maintenance-site-vpt ▶ Driveline - Active Issues... Question 9 Describe all modifications or changes made All Documents

PE13-002

VOLVO TRUCK

QUESTION 9

Solution:

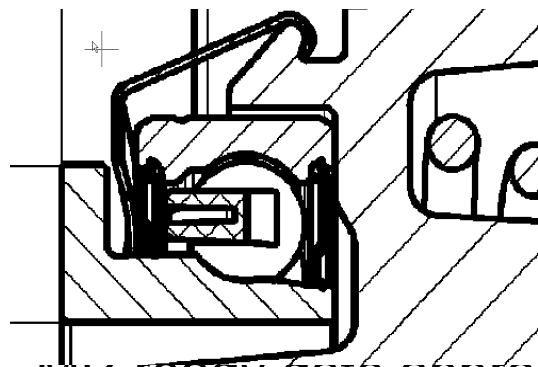
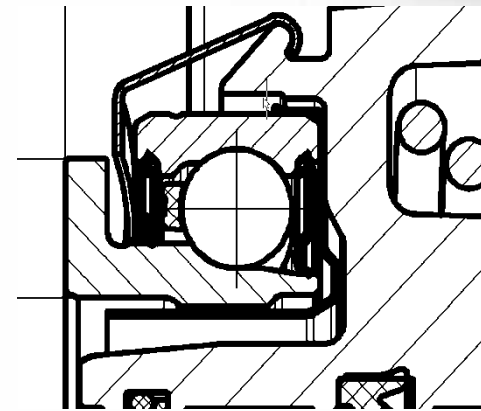
- Block-paste of the bearing, see presentation "CCA Bearing block-paste". This will also reduce the dust impact.

- Preliminary cost : part cost 0 Euro, tooling 35 KEuro
- Reman of CCA still to be discussed

- Time plan
 - Commercial agreement Volvo/Sachs: OK
 - DCN D-14185-97
 - New part no OK
 - Release of Drawing and models OK
 - K-DCN OK
 - DCN release OK
 - DVP sachs OK
 - Tooling and modification of production line: 2010w05
 - Initial samples PPAP: 2010w07
 - - SOP: 2010w09
 - Deviation Duro plastic rot. Lock for use up at supplier

Today's Bearing Design Parts

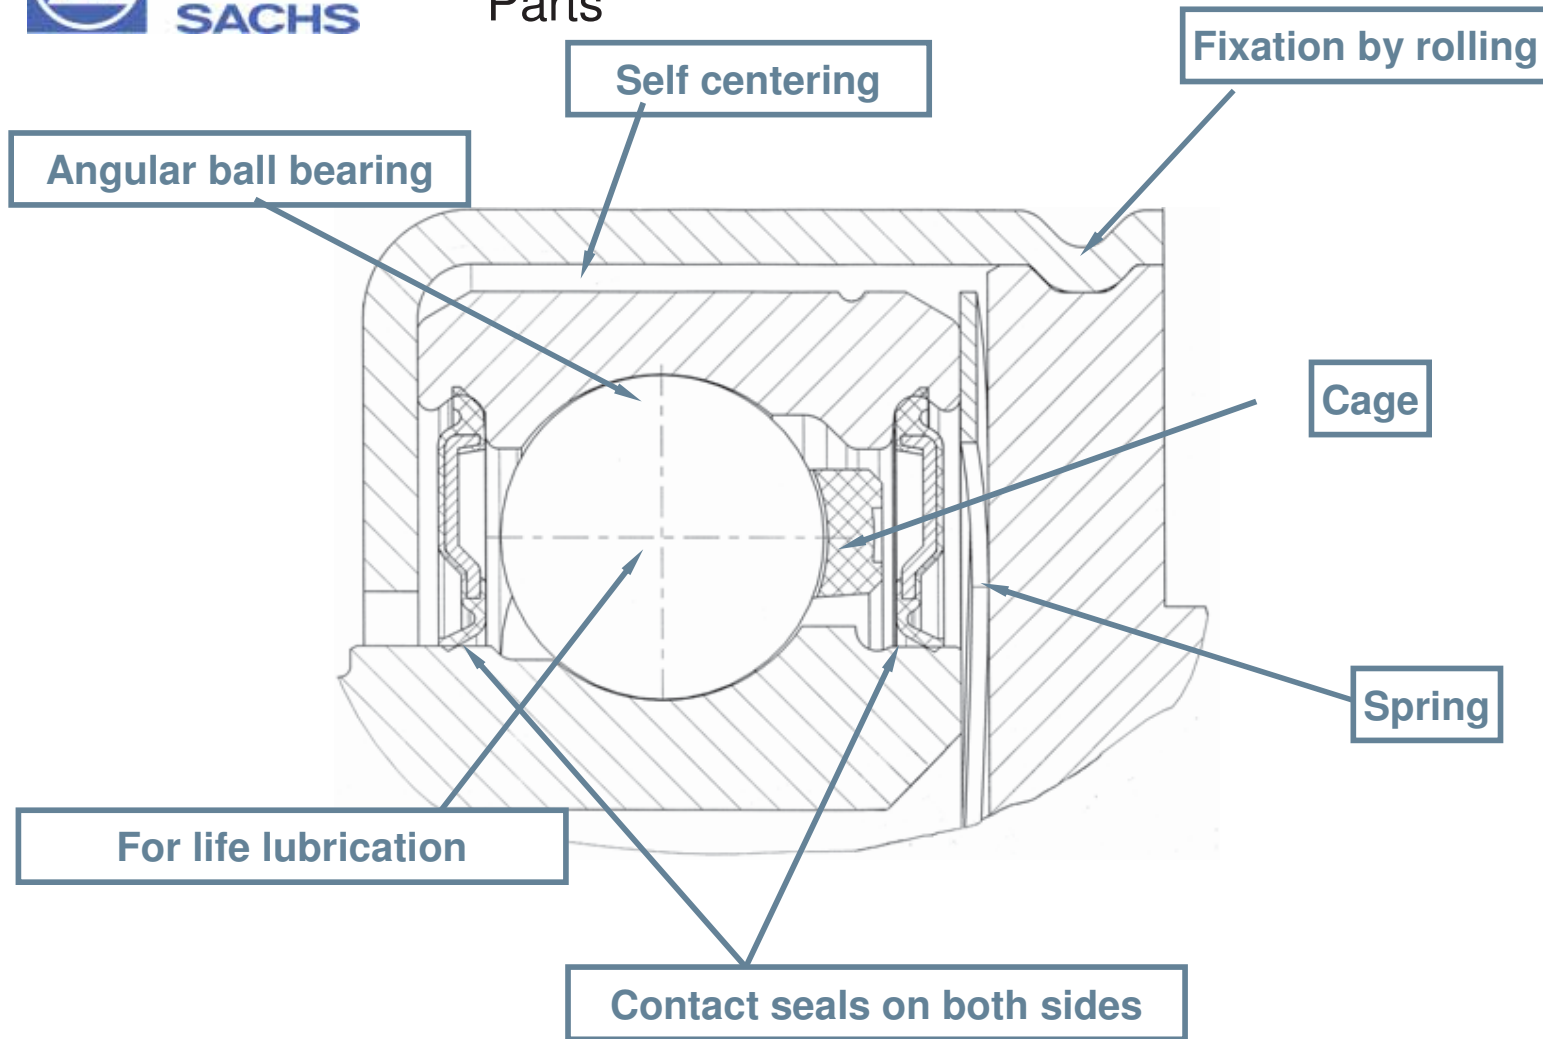
- Bearing clearance will be decreased □ decreases axial movements
- Theoretically will the bearing temperature increase
 - Construction +0,20 K (by 90 K air temperature of the housing)
 - Long Haul + 0,05 K
- The change affects first of all KZISZ-5 bearings (Volvo: SMT-bearings)
- The change will be introduced in the part list
- The change of outer ring and inner ring will be introduced in one step
- The last change will be block paste and block paste holding disc
- The block paste will be introduced im Oktober 2008

Clutch disc damper friction device

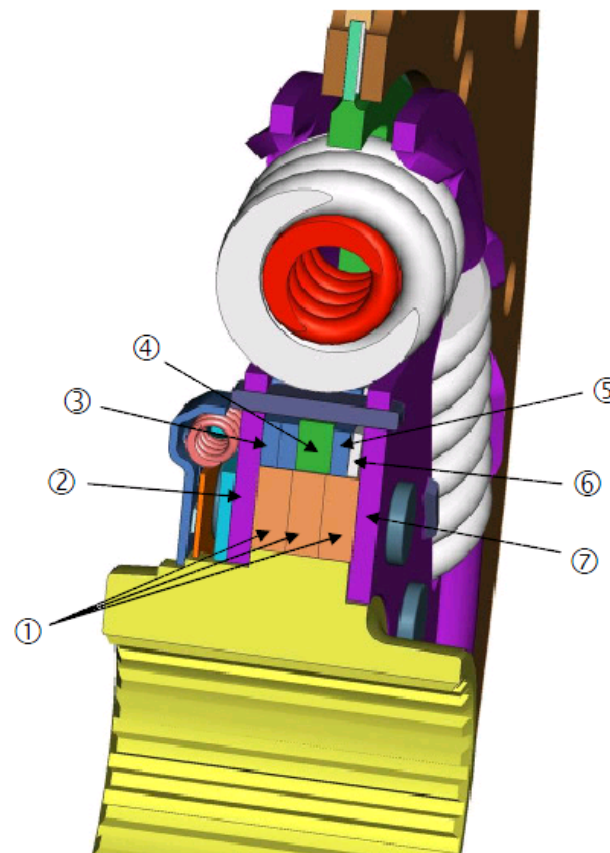
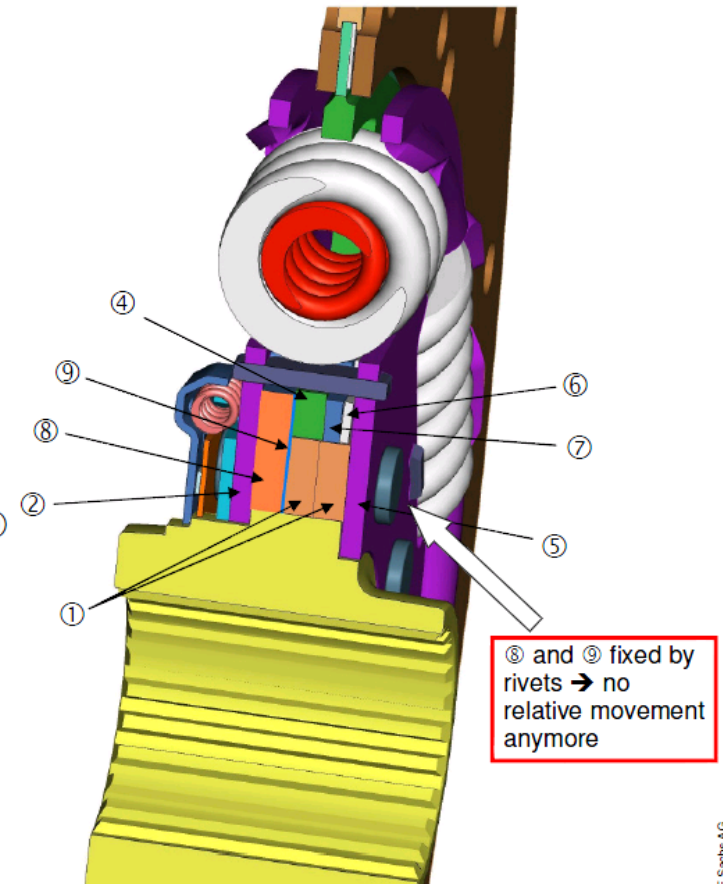
- Retainer plate ②
- 1x Hub friction ring ⑧
- 1x Hub friction ring (friction layer) ⑨
hardened → lower wear
- Driven disc ④
- Gearbox sided friction ring ⑤
- Belleville spring ⑥
- Retainer plate ⑦

- Field tests in UK, Finland and Sweden. W22->
- Accelerated test for wear on friction device, TBD

QJ 1-1359387371 Clutch disc spring worn or broken

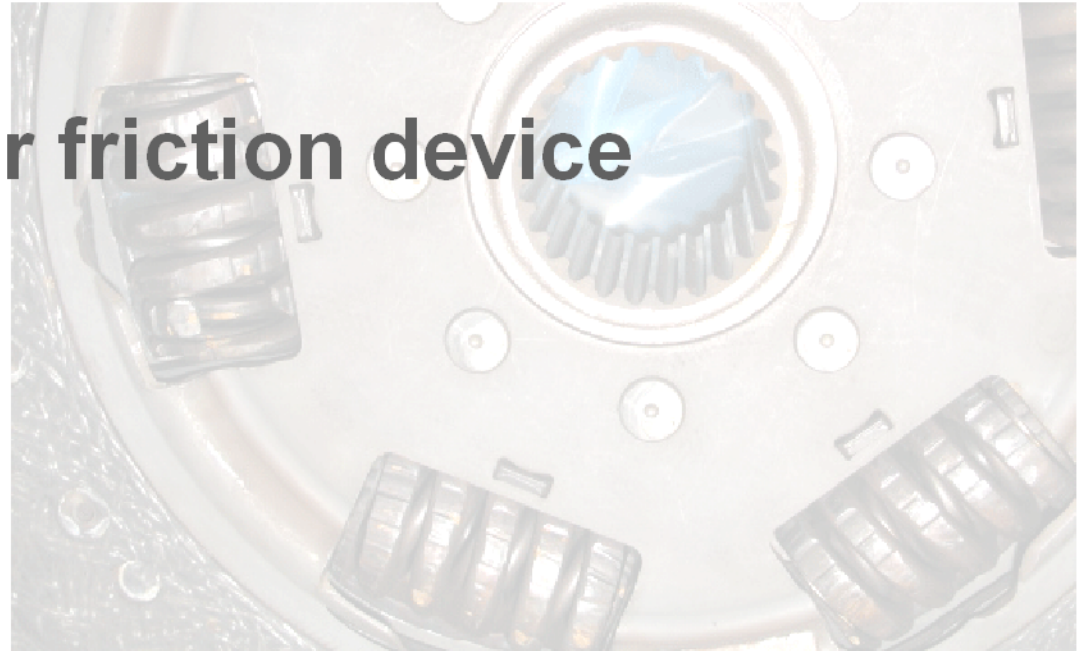
- Introduction date: 2011w05
 - Friction device change
 - Retainer plate material change

Clutch disc damper friction device

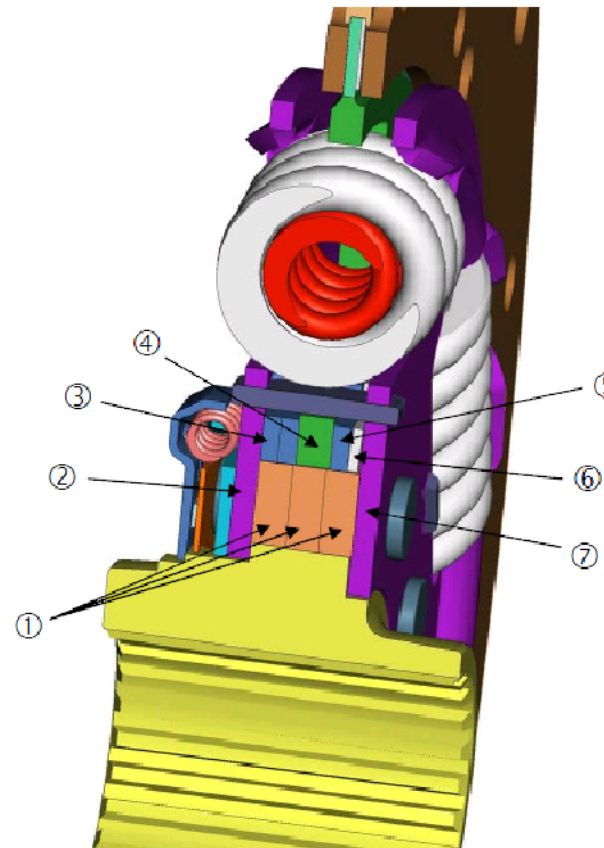
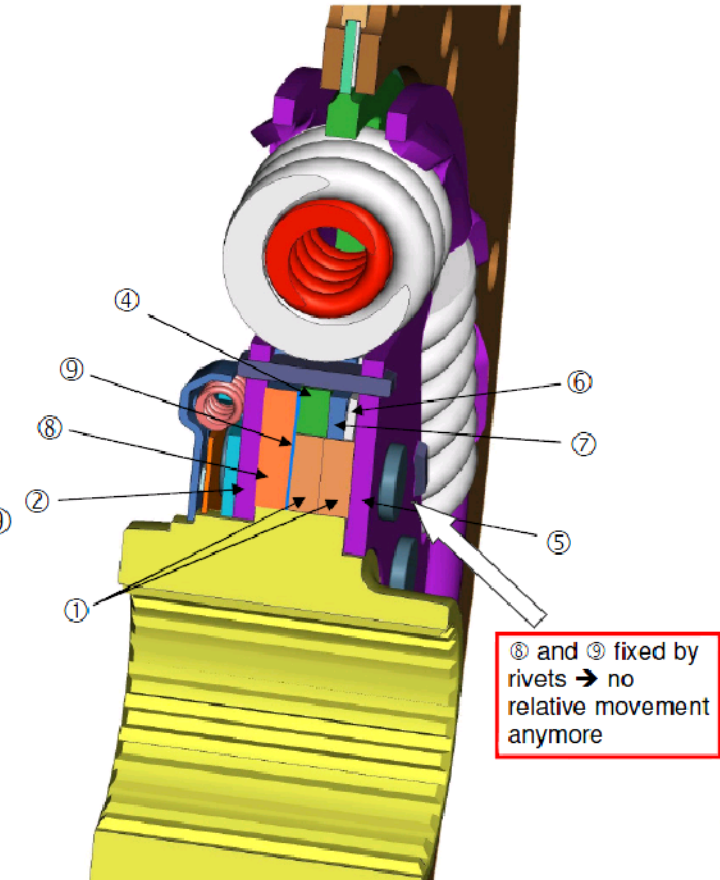
- Retainer plate ②
- 1x Hub friction ring ⑧
- 1x Hub friction ring (friction layer) ⑨
hardened → lower wear
- Driven disc ④
- Gearbox sided friction ring ⑤
- Belleville spring ⑥
- Retainer plate ⑦

- Field tests in UK, Finland and Sweden. W22->
- Accelerated test for wear on friction device, TBD

Clutch valve unit P/N 21206430

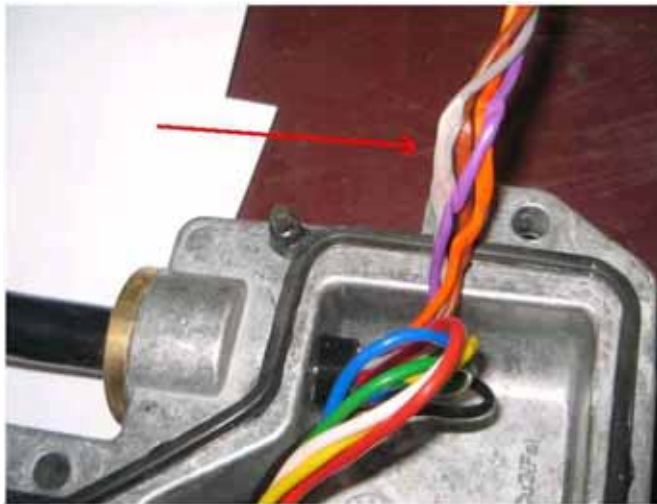
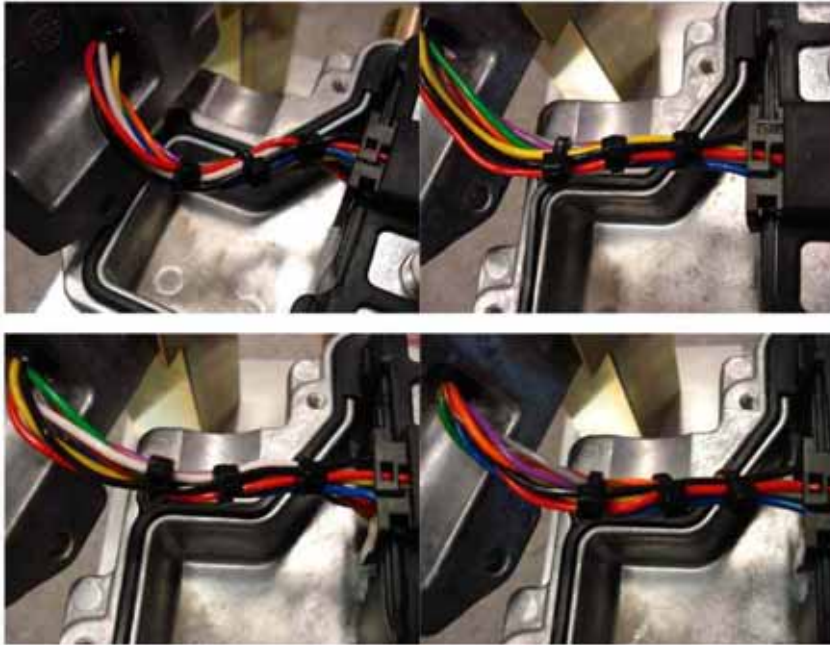
Due to not sufficient clamping of CVU internal cables, there have been claims of electrical connection broken and of water intrusion. Some cables have been squeezed between cover and housing during assembly at supplier.

Before S/N 36050:

After S/N 36050 the assembly process has been changed. 3 cable ties are mounted:

Design Changes on the CCA, preventive actions after field monitoring

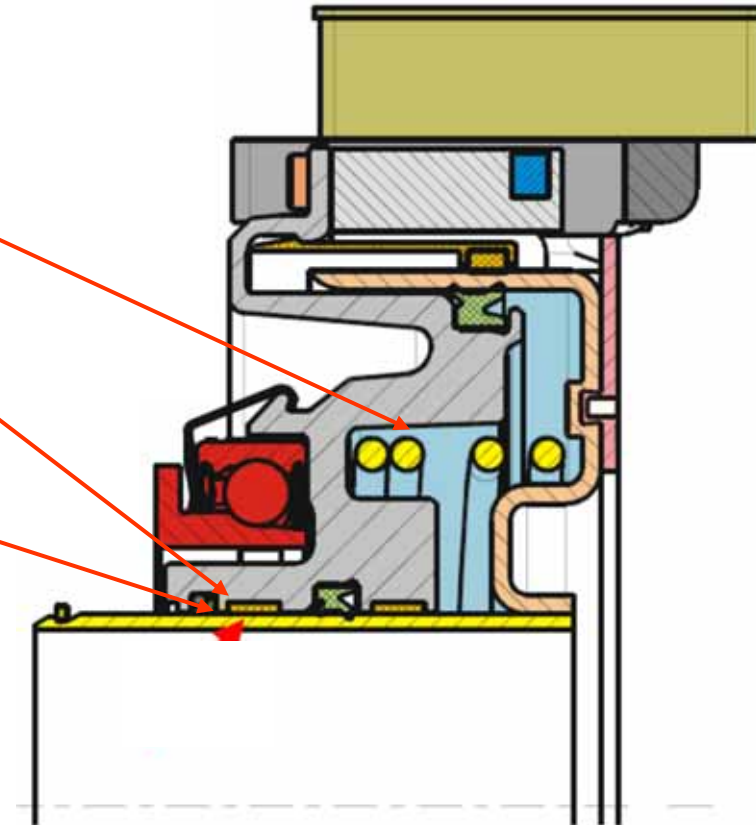
- **Short term design changes (introduced July 2008):**
 - Lower force pre-load spring for the 38mm-CCA
 - Broader Engine side guiding stripe (from 9,5 mm to 13,5 mm)
- **Mid-term design changes (planned for introduction January 2009):**
 - Change of material of the guiding stripes (from PTFE to H1)
 - New pre-load spring for both the 30mm and 38mm stroke CCAs (change of pre-load from 360 N to 150 N).
